6634B-09

S E R V I C E N O T E

Agilent 6634B DC Power Module

Serial Numbers: ALL

Figure 3. Through-hole Board

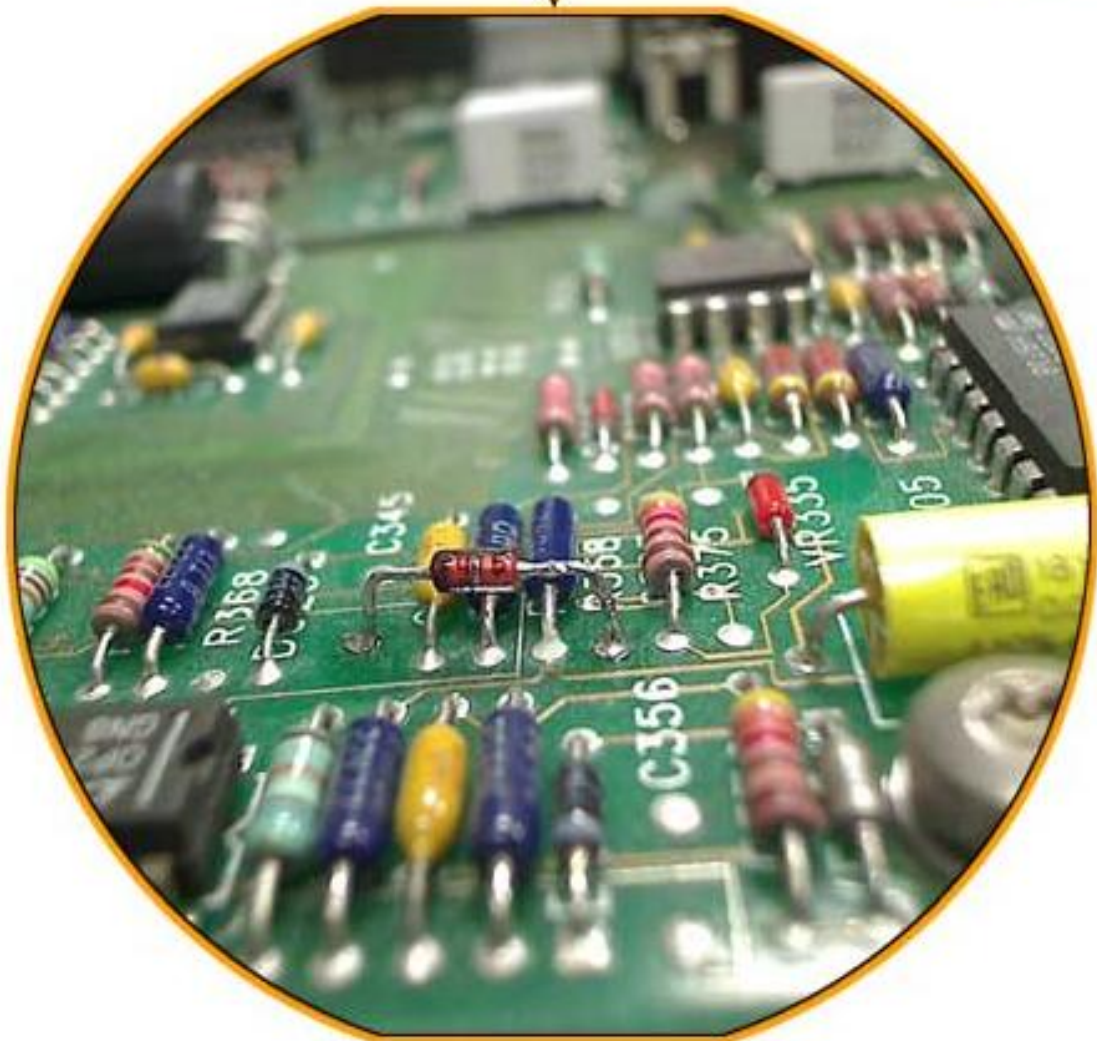
It is caused by a condition in which the current offset and voltage offset DACs do not reset, when the current and voltage programming DACs reset during an AC line sag. This results in an op-amp that normally operates at -5V DC to operate in the positive direction, and drives the output of the 6634B on.

The figures below show where to solder the diode (P/N 1901-1344) from R358 to C345 on the A1 main board.

The solution is to implement a diode (P/N 1901-1344) that clamps the op-amp to 0.7 V. This prevents the op-amp from driving the output on, and does not affect it due to a normal operation at -5V DC.
